## SERVICE BULLETIN AMATEUR RADIO

SUBJECT	DATE
TS-950SD N.B. GATE SWITCHING NOISE	01/11/90

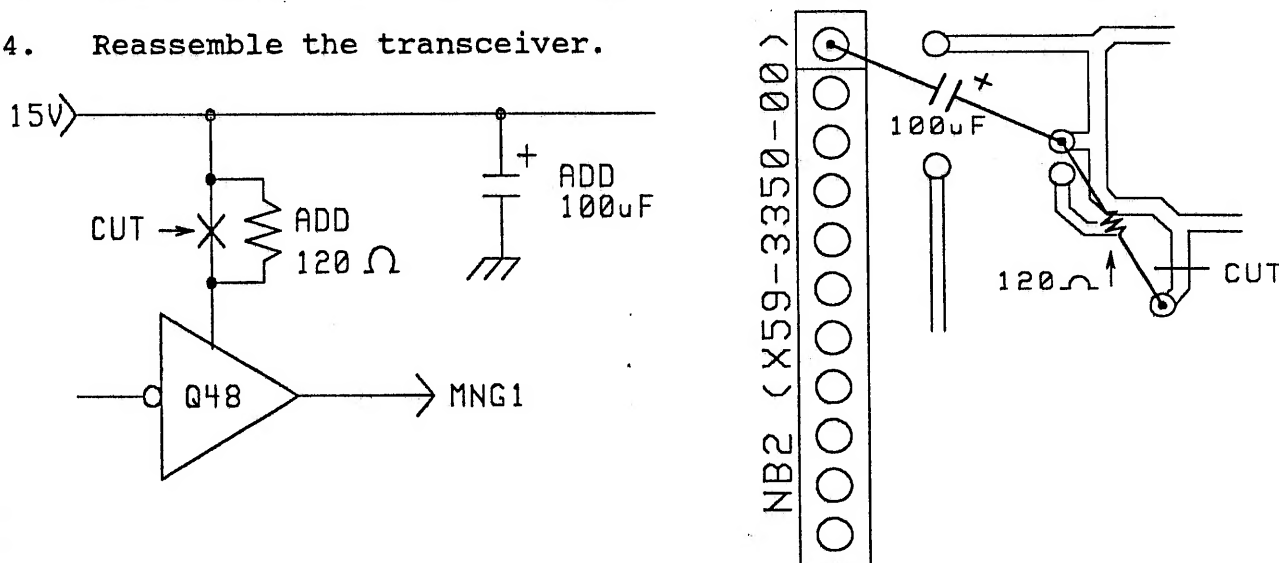
Switching noise from the main band noise blanker circuit may be induced on the 15V line and pass through the AF amplifier to the speaker. The following modification will correct this condition.

1. Cut the foil as shown in the accompanying diagram.
2. Add a 120 ohm resistor between the emitter of Q48 and the 15V line.
3. Add a 100uF, 16V capacitor between the 15V line and ground.
4. Reassemble the transceiver.
